June 1, 2015

Subject: Approval for Management of Contaminated Soil under Chapter NR 718 Wis. Adm. Code Generator Property: Georgia-Pacific Broadway Mill, 1919 S. Broadway Street, Green Bay FID # 405032870 WDNR Sites: Former Buth Oil Facility, BRRTS# 02-05-563707 Wisconsin-Michigan Auto Salvage, BRRTS# 02-05-000627

June 1, 2015 Mr. Michael Moore Approval for Management of Contaminated Soil Under Chapter NR 718 Wis. Adm. Code Former Buth Oil Facility – BRRTS # 02-05-563707

AREA OF IMPACT SOIL REMEDIATION AND APPROXIMATE EXTENT OF SOIL IMPACTS	FORMER WISCONSIN - MICHIGAN AUTO SALVAGE GEORGIA PACIFIC CORPORATION GREEN BAY, WISCONSIN
Drawn :	RLD 3/30/2009
Checked:	MWM 3/30/2009
Approved:	RAM 3/30/2009
PROJECT	200800962
Figure Number	2A

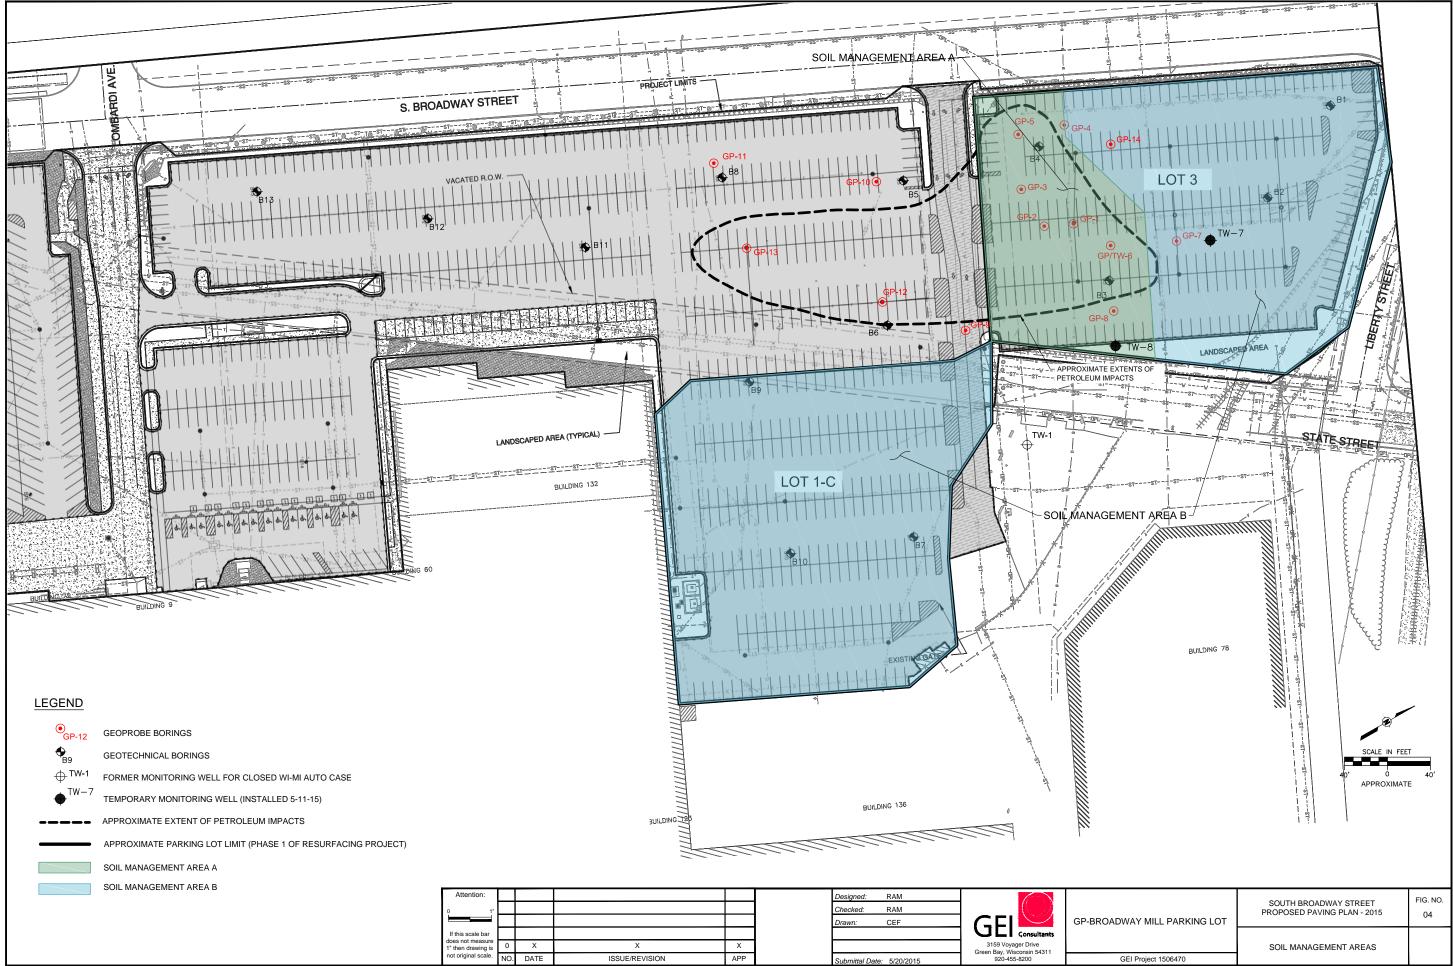
Phase 2 of the resurfacing activities is scheduled to be completed later in 2015 and will consist of resurfacing activities in the area of the former WI-MI Auto Salvage site (BRRTS# 02-05-000627) (See Figure 2A; Area of Impacted Soil Remediation and Approximate Extent of Soil Impacts). The soil in the area of the former WI-MI Auto Salvage site will be managed similar to the soil handling approach for soil management of Phase I Area A of Lot 3 as discussed in the SMP and covered under the s. NR 718 Wis. Admin. Code exceptions outlined in this letter. This would include soil disposal at a licensed landfill if chlorinated volatile organic compounds (CVOCs) are detected or if volatile organic compounds (VOCs) and/or metals are reported at concentrations higher than previously documented in Phase I Area A of Lot 3.

Prior to Phase 2 resurfacing of the WI-MI Auto Salvage site area, a Post Closure Continuing Obligation Request shall also be submitted to the Department along with the appropriate fees (Cap Modification or Removal of a site or property from the database fee \$1050 and Database fees of \$300 and \$350) for review and approval. Once the resurfacing has been completed a Post Closure Modification Final Documentation Report shall be submitted to the Department for the WI-MI Auto Salvage site area, including a revised maintenance plan, photos, and any appropriate maps. It will also be necessary to document, in a report, the Phase I resurfacing activities in Areas A and B. It is acceptable to summarize the Phase I and Phase II resurfacing activities in one report.
